Section 12A Planning Application for Proposed Amendments to the Tung Chung Valley Outline Zoning Plan to Rezone “Residential (Group C)2” Zone to “Residential (Group B)” Zone in Support of Private Residential Development at Various Lots in D.D. 1 TC and Adjoining Government Land, Tung Chung, Lantau Island (Application No. Y/I-TCV/1)

In response to the Transport Department (TD)’s comments received on 9 April 2025, the Applicant would like to submit herewith responses-to-comments (RtoC) table (**Appendix A**) with replacement pages of Traffic Impact Assessment enclosed herewith in **Attachment 1** for the Board’s consideration.

FIGURE 2.1

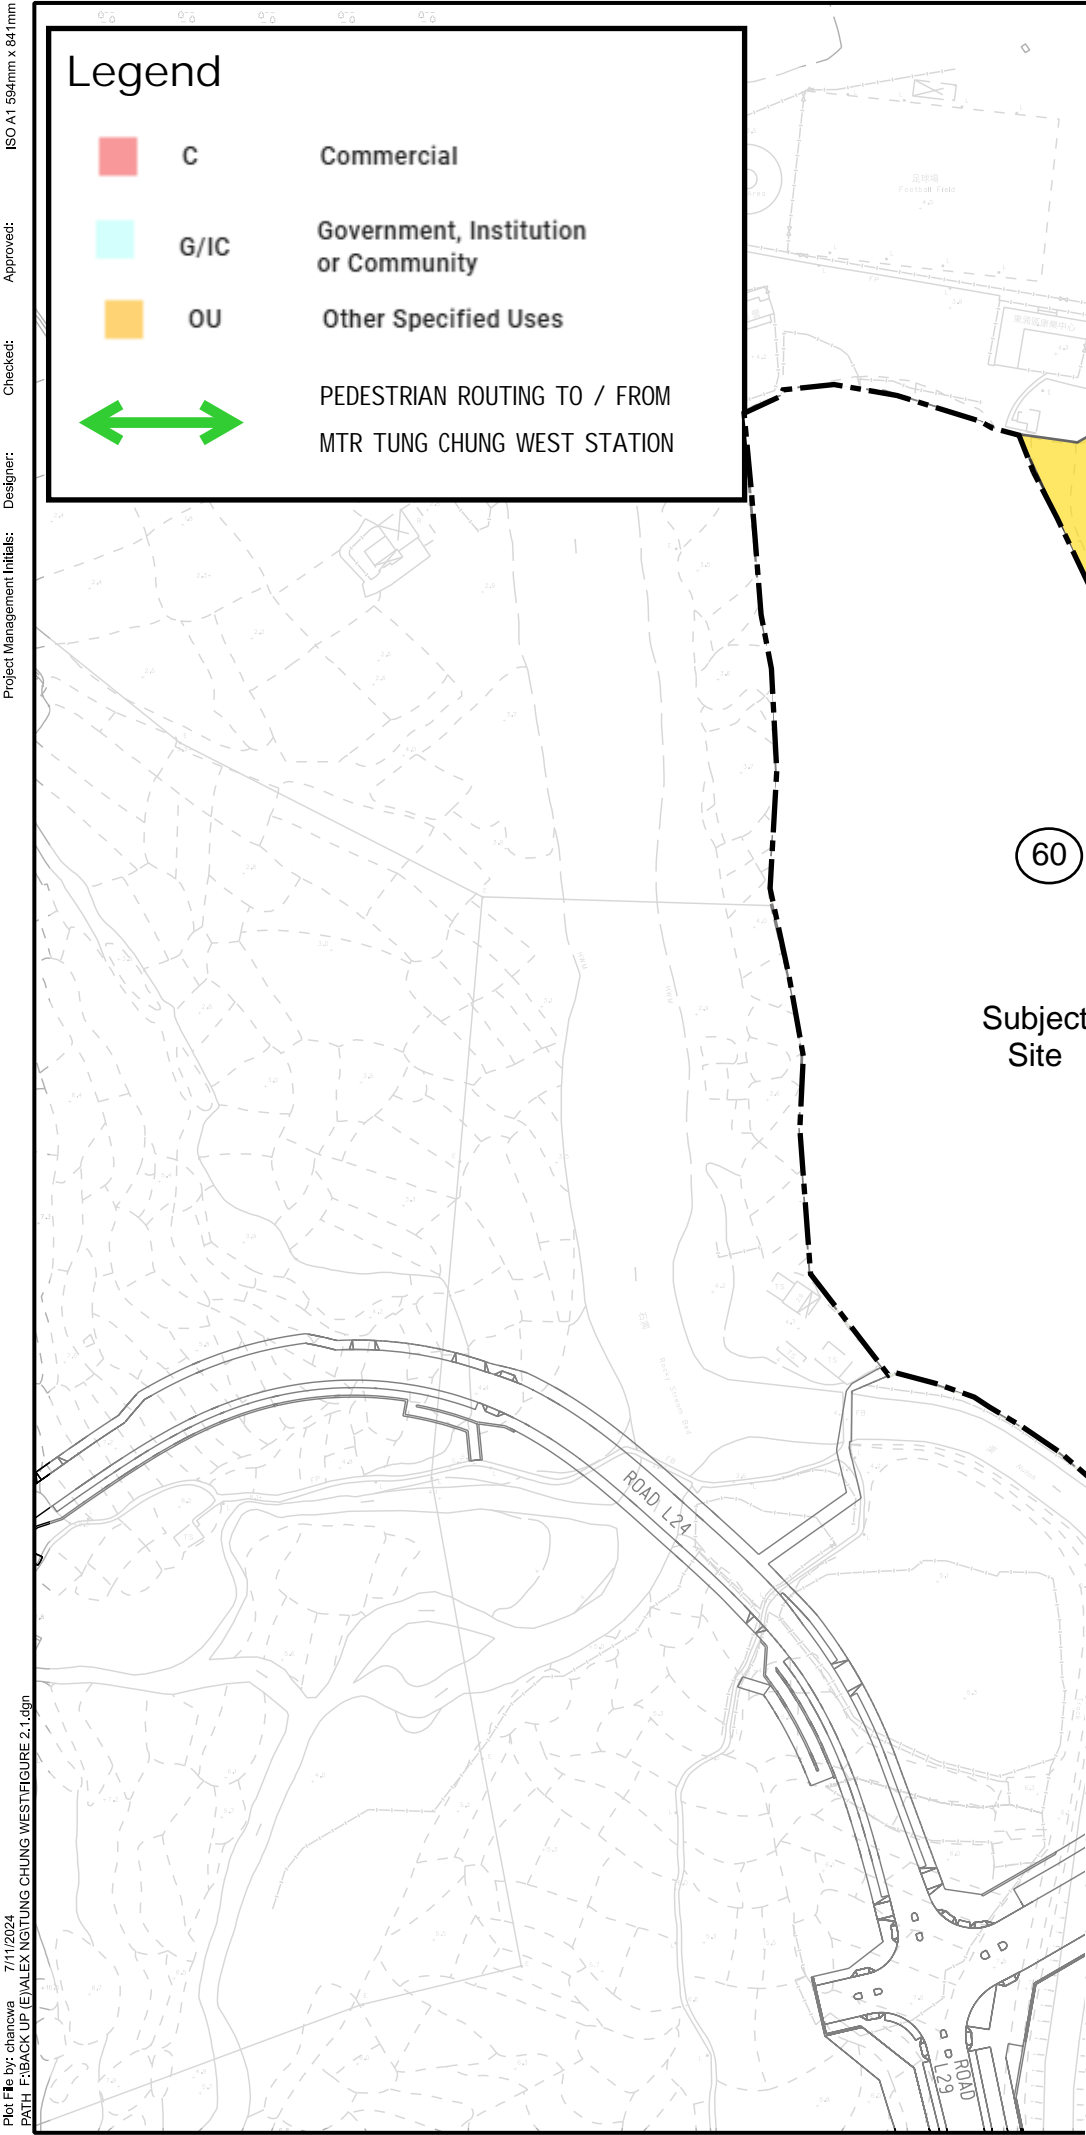
1.8	<p>Re. 2.3.1 – The paragraph related to the Area38A PTI is still found in the TIA. There is no update on the latest submission.</p>	<p>Please note that Para 2.3.1 is referring to the proposed Private Transport Layby within the Application Site. Figure 2.1, Figure 5.2 and Figure 5.3 have been revised to remove text mentioning Area 38A PTI (refer to Attachment 1).</p>

FIGURE 5.2

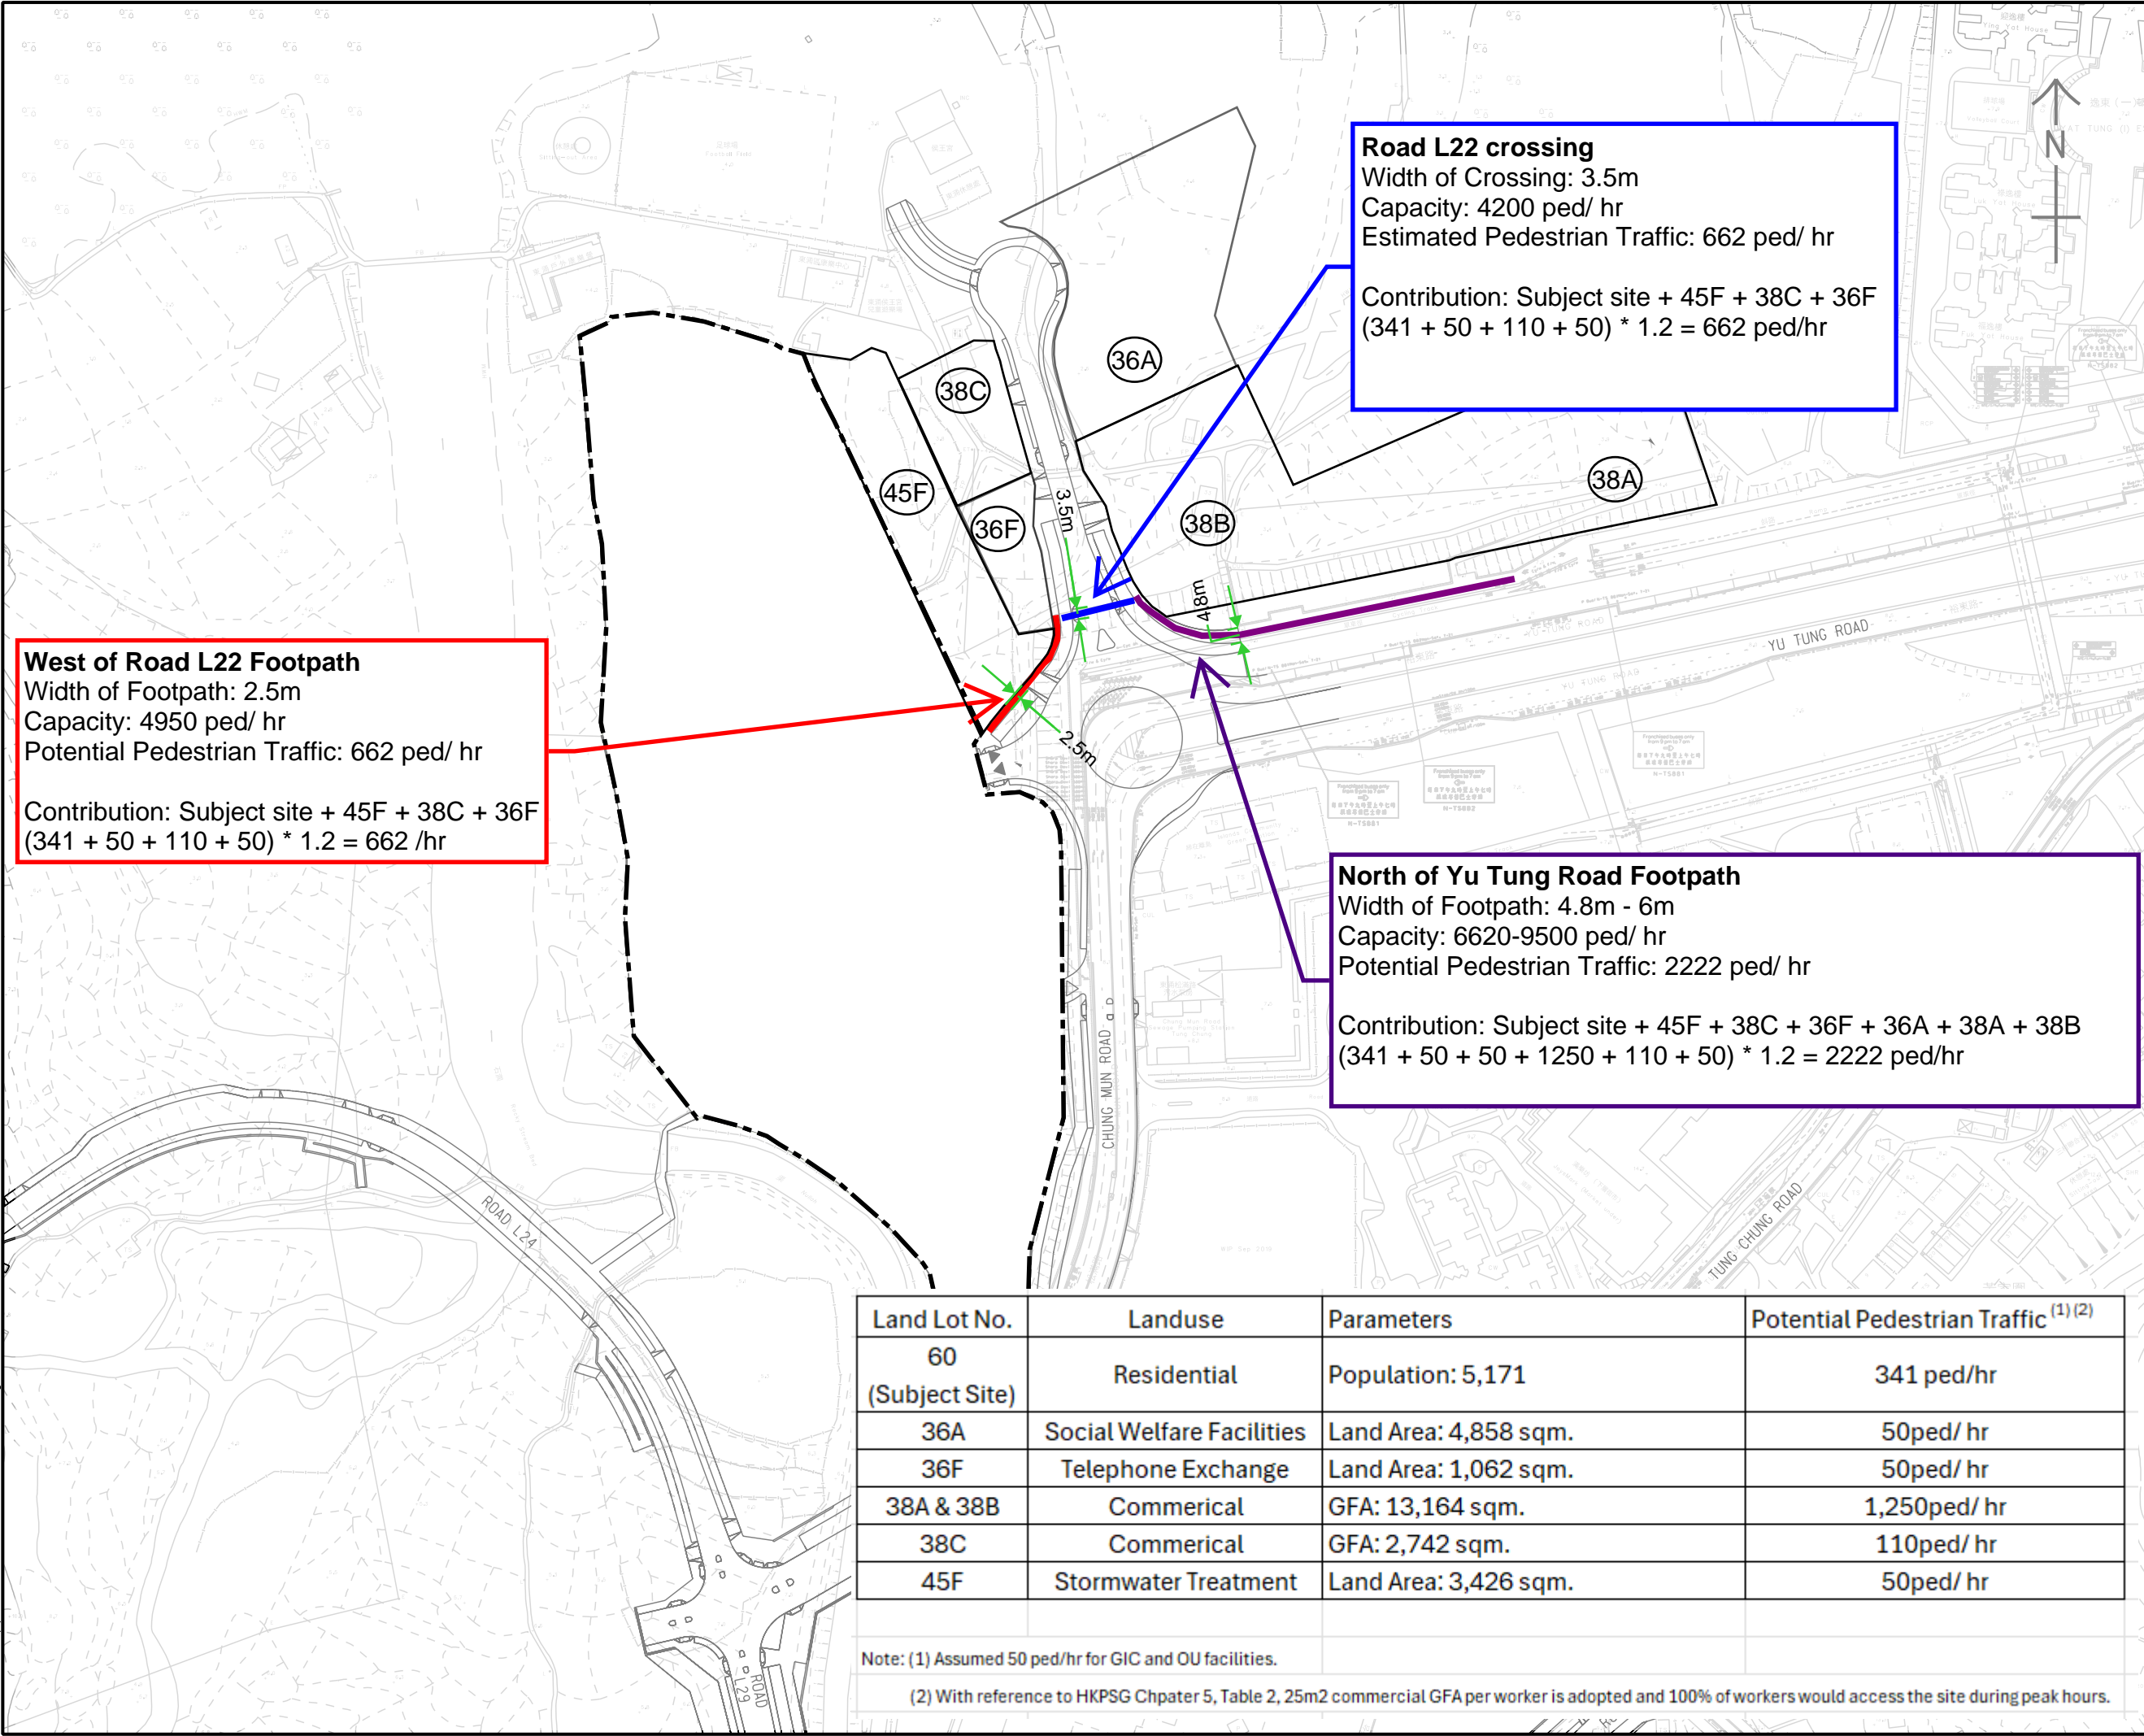
Departmental Comments	Responses to Comments
1.3	<p>Re. Para 5.4 – As there will be commercial development and transport lay-bys within the subject site, please also provide the relevant pedestrian impact assessment for the crossing on Chung Mun Road and the footpath nearby between Mun Tung Estate and the subject development.</p> 	<p>Assuming a portion of pedestrian from Mun Tung Estate would access the retail facilities and transport lay-bys of the subject site (10% assumed): $11,400^{(1)} \text{ (population)} \times 1.83^{(2)} \times 12\%^{(2)} \times 10\% = 250\text{ped/hr.}$</p> <ul style="list-style-type: none"> (1) Population adopted from Report on Population and Households in Housing Authority Public Rental Housing (December 2024) (2) According to Travel Characteristics Survey 2011 Final Report, the daily mechanised trip rate per population is 1.83 trips and the morning peak hour accounted for about 12% of the daily trips  <p>Crossing width = 3.5 Capacity = 4200ped/hr Expected flow = 250ped/hr</p> <p>Capacity of Crossing - As per TPDM Vol. 2, Table 3.7.2.1, a 3.5m crossing can cater for up to 4200ped/hr. The expected flow of this crossing is only 250ped/hr. Therefore, the provided pedestrian facilities is considered sufficient.</p>
